Subject: Revision 6 of the Proposal for the Fast 80 Specifications in the SPI-3 Standard

The SPI-3 T10 working group meeting reviewed revision 5 and marked it up with changes to be made as agreed to in the meeting. The working group meeting recommended that revision 5 as marked up be incorporated into SPI-3. Revision 6 incorporates the mark-ups made in the meeting.

Attachment: Fast 80 Draft for SPI-3 Revision 6 by PDF.

Figure 1 - ~~Fast-40~~ Single Transition mode LVD timing measurement points

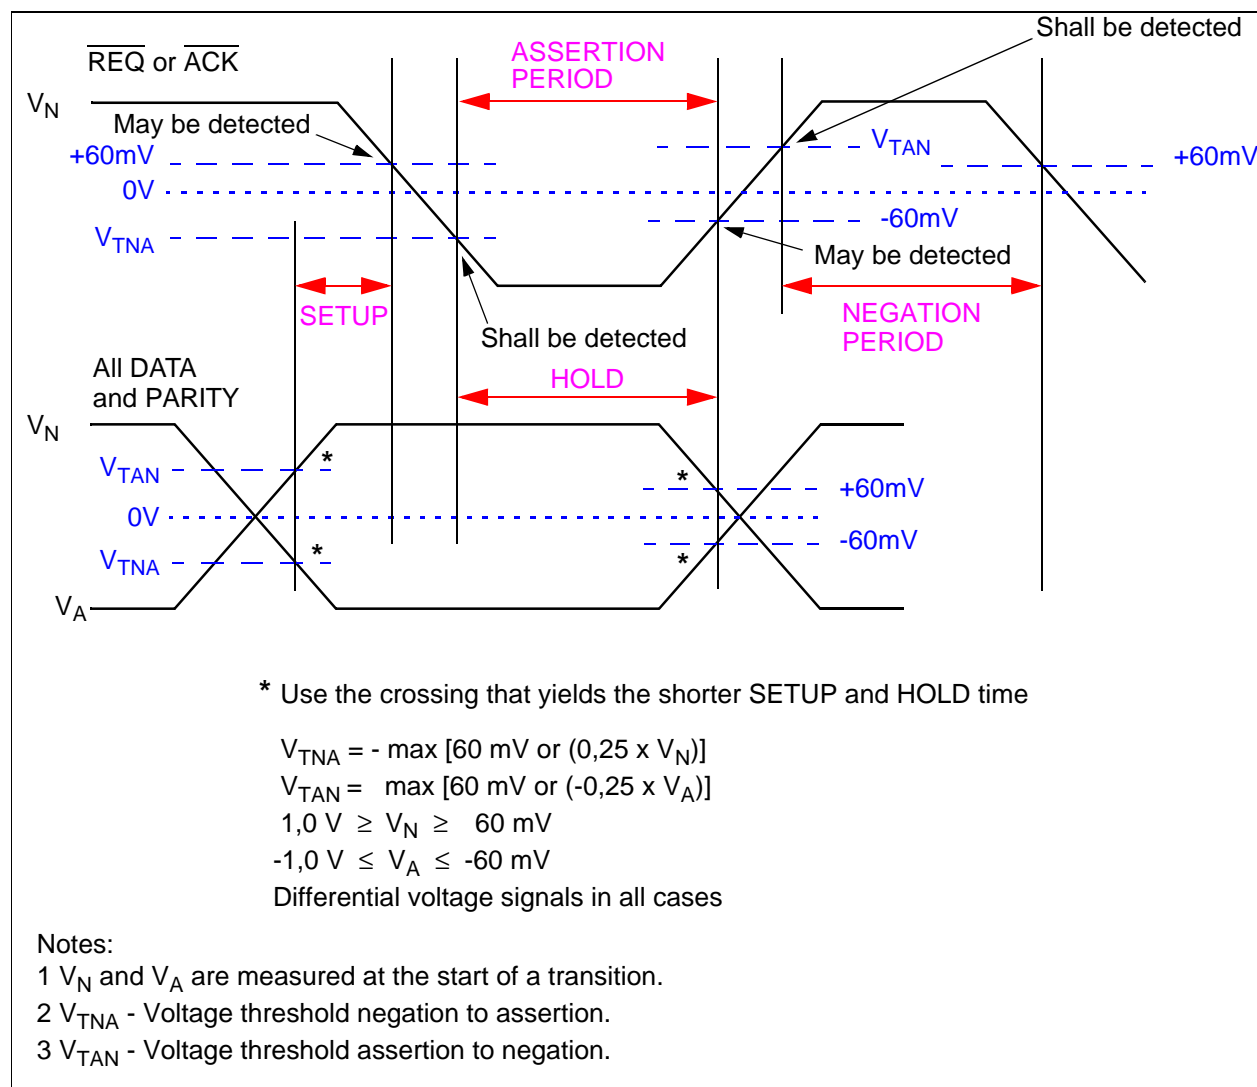
1.2.2 LVD ~~≤40-MT/s~~ Single Transition

LVD SCSI devices with a single transition agreement shall use the measurement points defined in figure 1 for the measurement of the timing values. The rise and fall times for the LVD REQ/ACK signals shall be nominally the same as for the LVD DATA/PARITY signals.

Figure 4 - Fast-80 Double Transition System setup and hold timings (all times in ns)

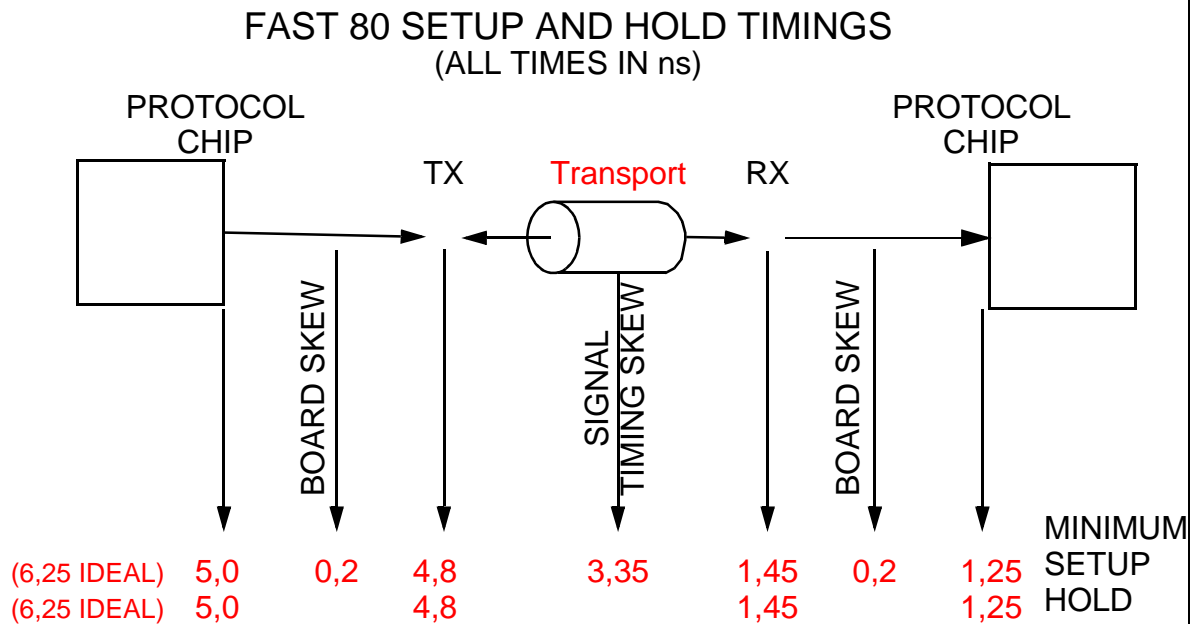
~~INT T/R indicates integrated protocol and transceiver chip~~

~~Board skew includes the separate transceiver and trace skew~~

Signal timing skew includes cable skew and signal distortion skew

Distortion skew includes ISI (intersymbol interference) and differences in signal crossing time through the receiver detection range
